**Rutland County Council**

Application:	<b>2022/0646/FUL</b>	<b>ITEM 1</b>	
Proposal:	<b>Demolition of existing agricultural barn and erect 2 no. 3 storey dwellings, relocation of entrance doors to barn No 2 to the rear, extension of existing farm track, creation of new parking and turning area to the rear of barn 2.</b>		
Address:	<b>Fairchild Lodge, Lyddington Road, Caldecott, Rutland</b>		
Applicant:	<b>Mrs Louise Brown</b>	Parish	<b>Caldecott</b>
Agent:	<b>Mr Tony Ansell</b>	Ward	<b>Lyddington</b>
Reason for presenting to Committee:	<b>Member application</b>		
Date of Committee:	<b>14 February 2023</b>		
Determination Date:	<b>21 July 2022</b>		
Agreed Extension of Time Date:	<b>17 February 2023</b>

Block Plan (part) showing parking/  
 turning 1:200 @ A4.  
 Ref: AB/03C/PL/2022

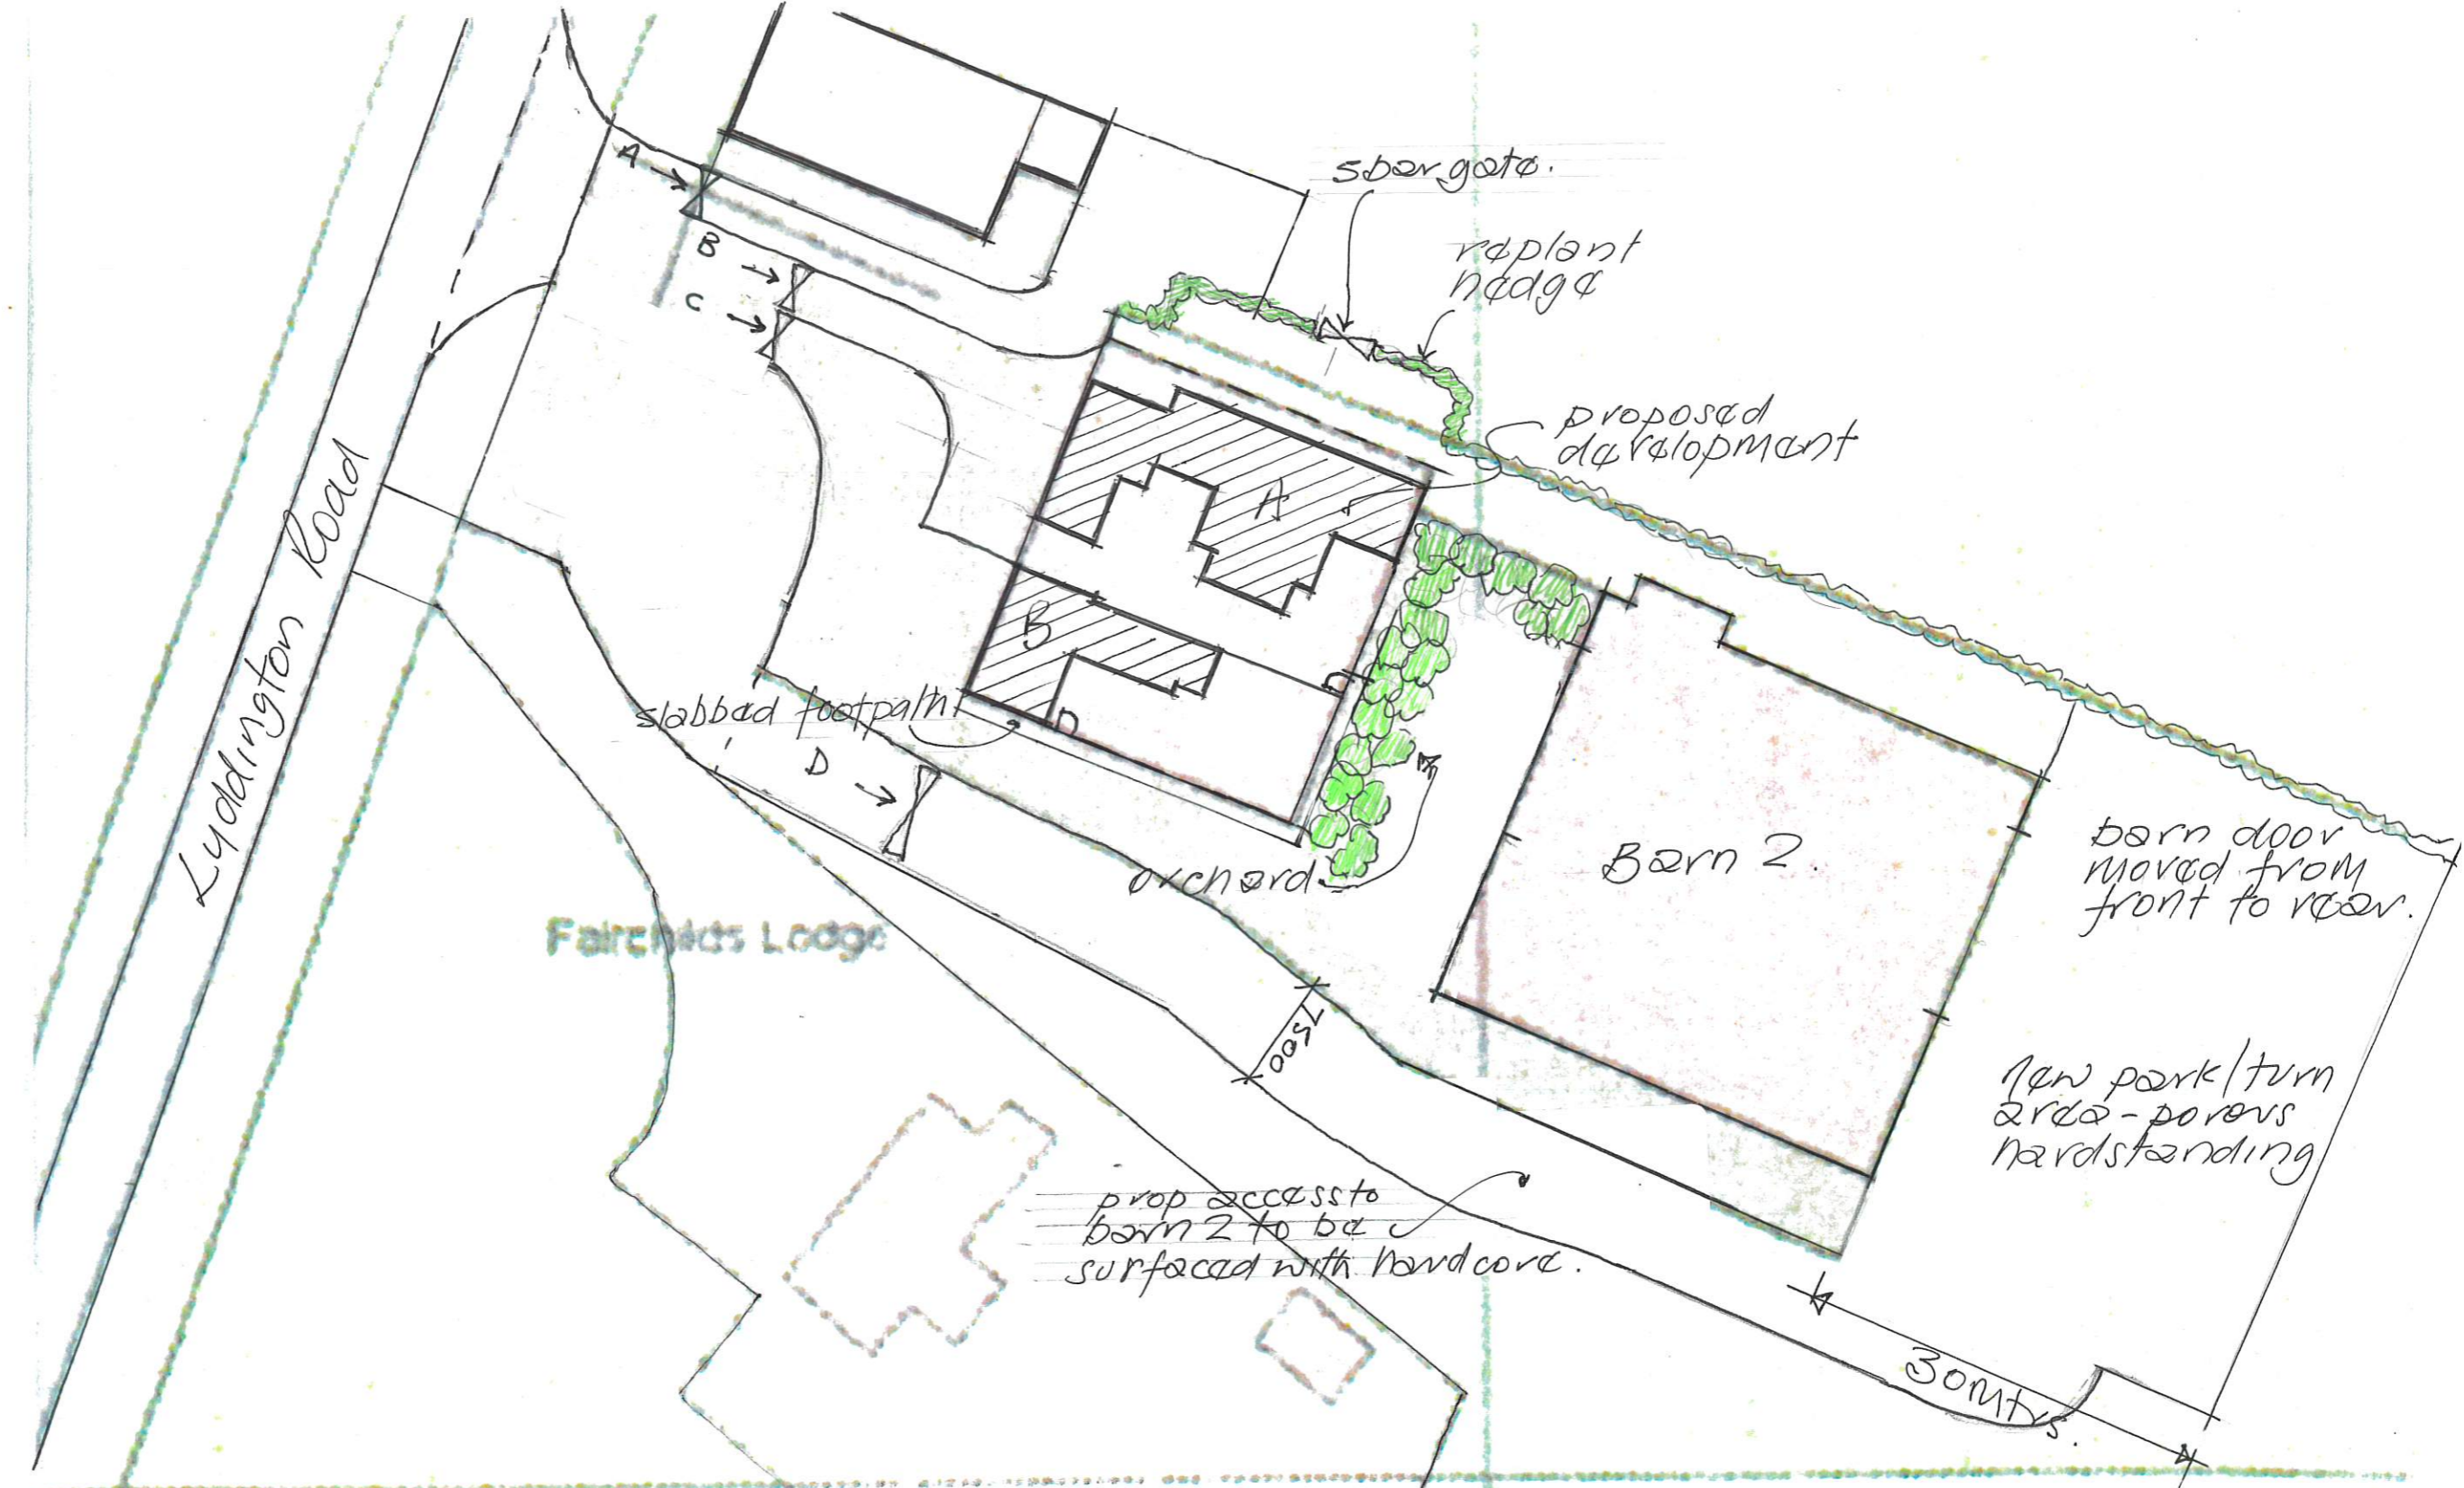
LHA - further information is needed to clearly show parking and turning for the 2 dwellings (all drawings to include dimensions)

At present it is not clear how many spaces are provided for each property and where the vehicles can turn to ensure they enter the highway in a forward direction

No Objections following the submission of the revised block plan showing parking and turning submitted on 22/12/2022

AB/01B/PL/2022

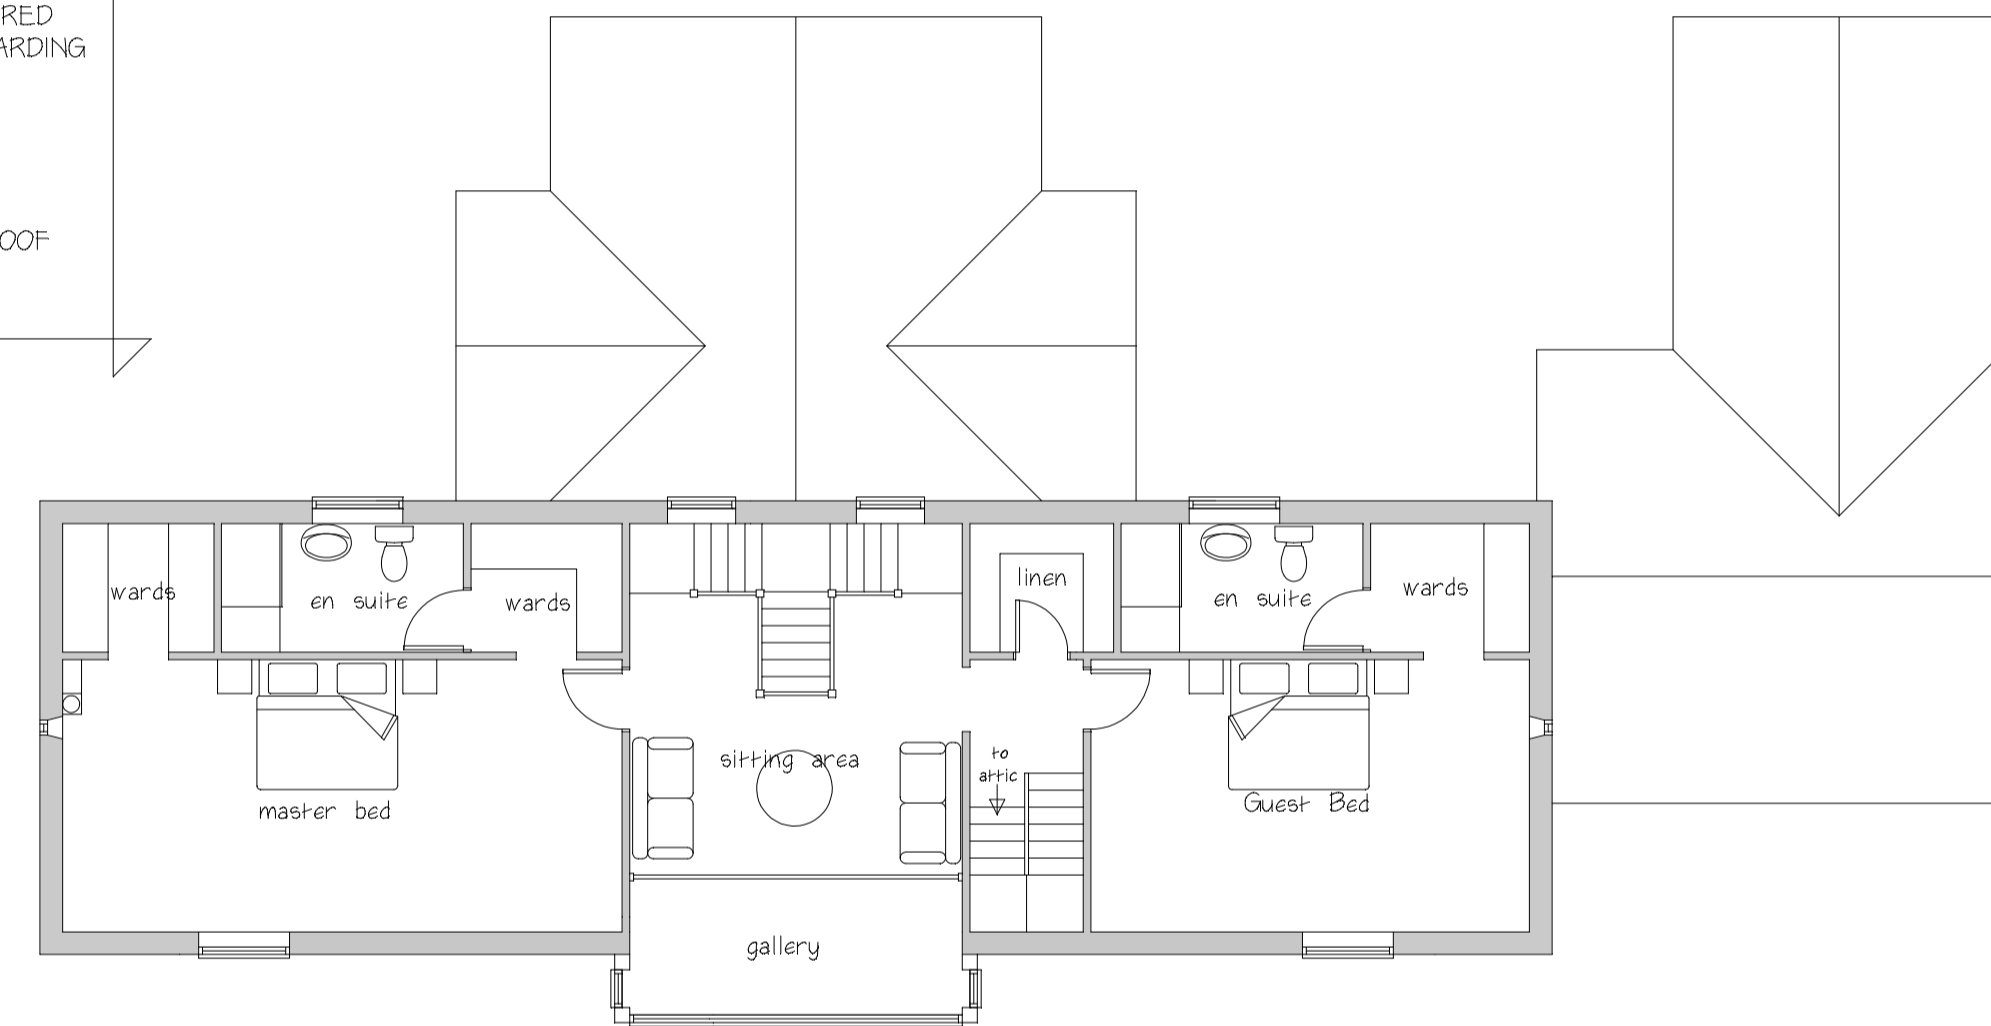
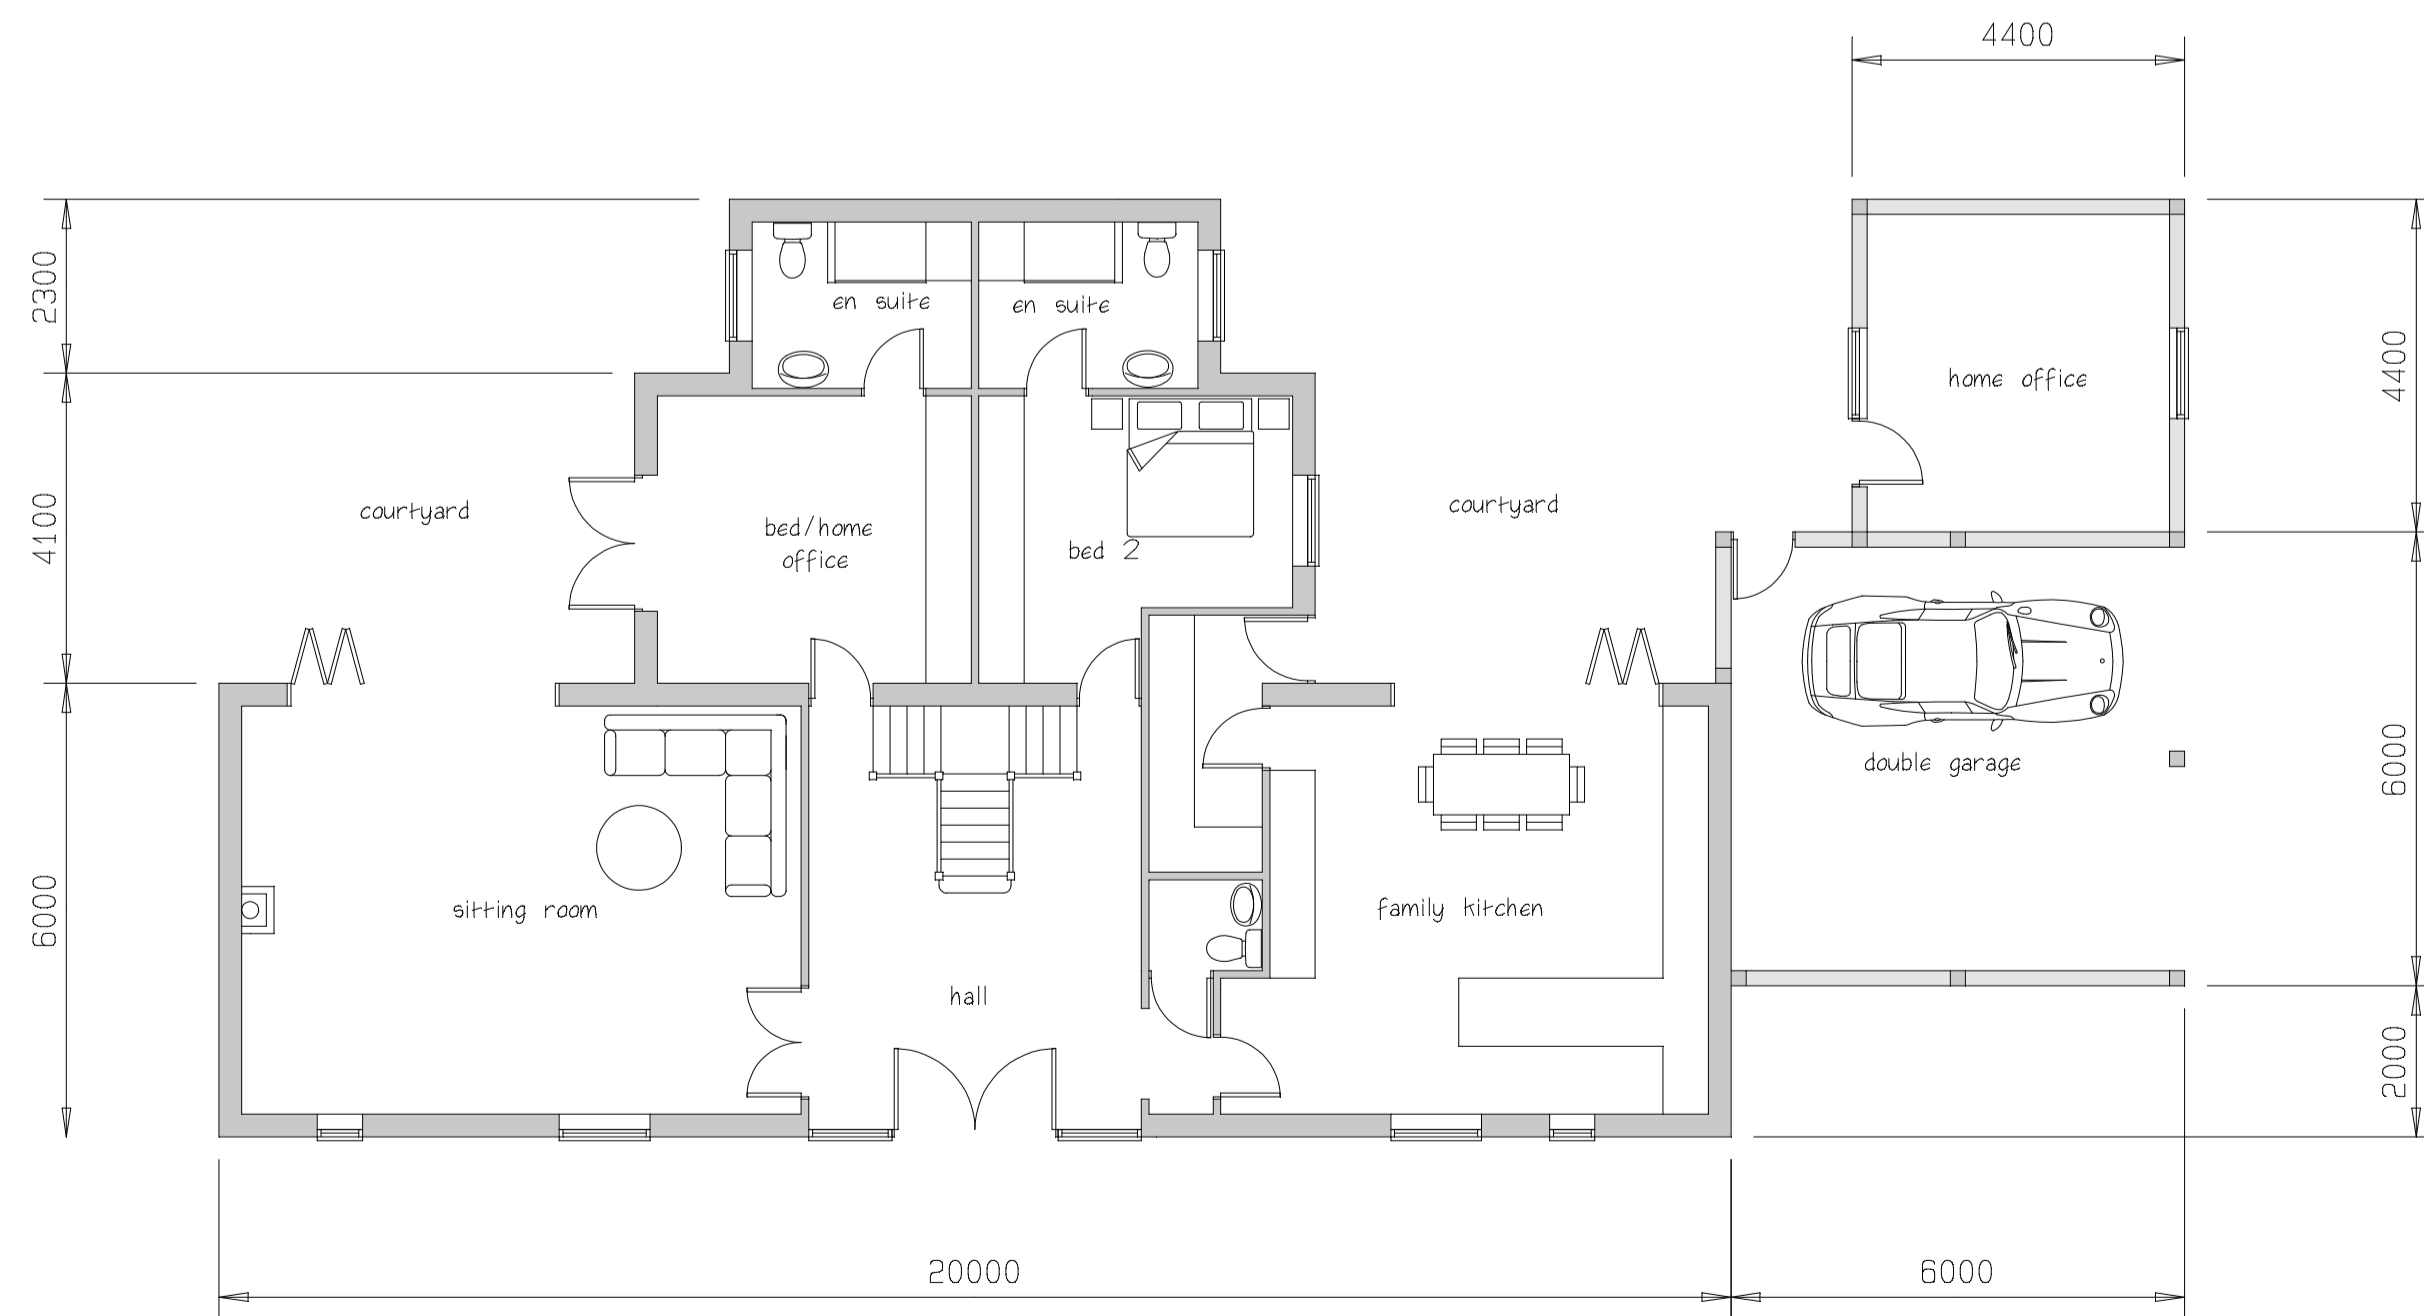
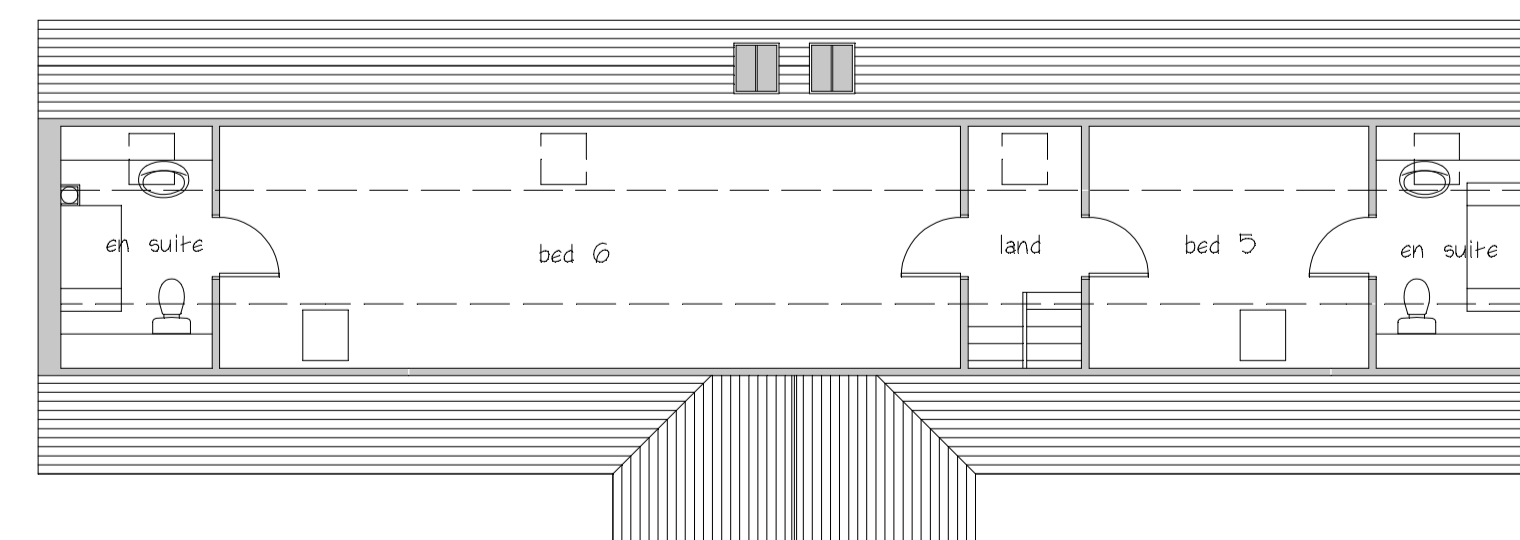
Dwelling A - central glazed element now all one as discussed - Dwelling B - solid element under porch removed allowing porch to overhang - although there is now a smaller solid element labelled 'store' - more info on this needed - assuming brick? If having, needs recessing behind timber posts but may still look odd

REV A: GLAZING REDUCED TO THE FRONT ELEVATION & ROOF WINDOWS TO REPLACE DORMER WINDOWS FOR DWELLING 1  
 REV B: VERTICAL TIMBER BOARDING AND RENDER TO FRONT ELEVATION FENESTRATION ALTERED TO FRONT & STAIRWELL. FLUE ADDED
